Agenda – Appeal Committee – January 14, 2026

Item No. 2 Appeal – Variance – 36 Roslyn Road
(Fort Rouge-East Fort Garry Ward)
File DAV 204666A/2025D [c/r DAZ 220/2025]

ADMINISTRATIVE REPORT

Title: DAV 25-204666\D – 36 Roslyn Rd

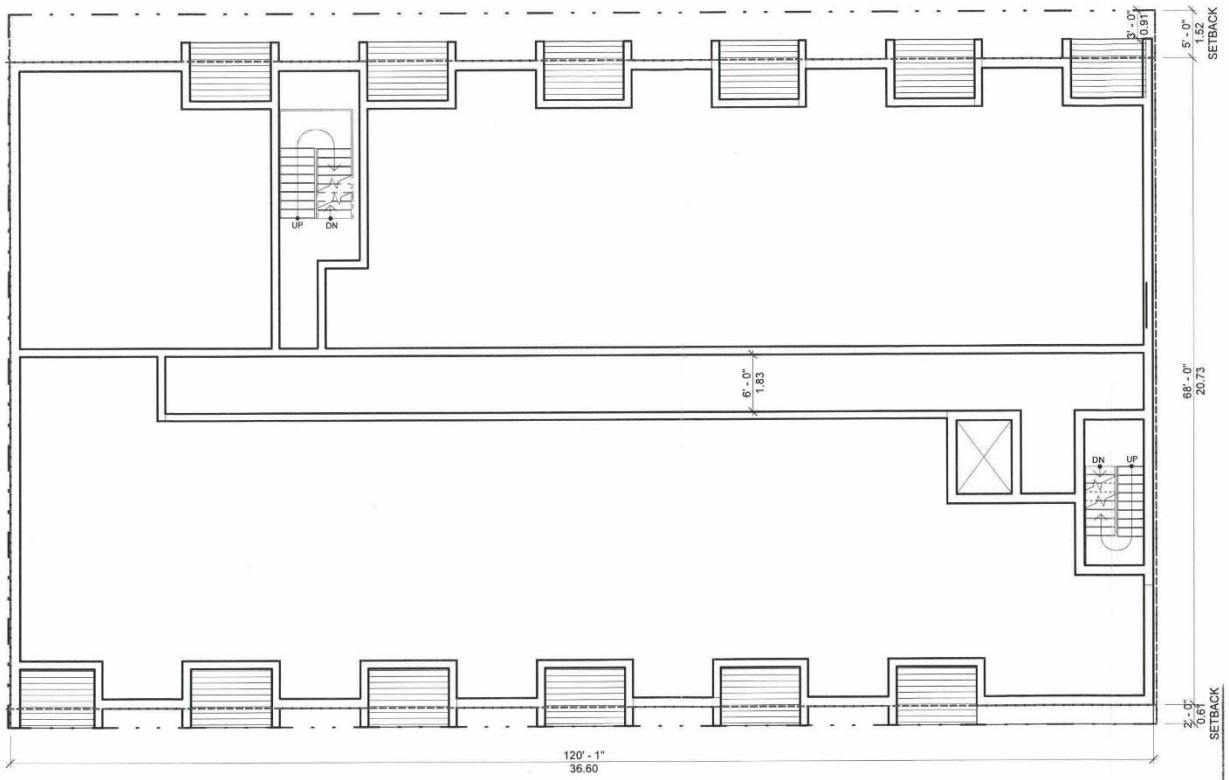
- The site plan also shows:
    - A garbage enclosure located at the southwest corner of the subject site.
    - A total of 21 parking spaces, including six accessible stalls, primarily located in covered parking at ground floor.

- 52 secure, indoor bicycle parking spaces.
    - A total of 0 trees and 44 shrubs.
- No affordable units – which would normally be required per the City of Winnipeg’s Density Bonus Program – are proposed.

The parking is accessed from the rear lane, with much of the parking fully enclosed within the main floor of the building, and six stalls partially covered by the cantilevered upper floors of the building. No approaches from the streets are proposed. These features minimize conflict between pedestrians using the sidewalk and motor vehicles accessing the street, and they ensure the public boulevard of Roslyn Road and Bryce Street are not fragmented.

- Given the proposed development provides parking off the rear lane, it is not possible to provide a landscaped buffer between the rear of this property and the adjacent residential zoning district. No landscaped buffer between parking areas in at the rear of properties and adjacent residential development is a common feature of this neighbourhood, including this lane.
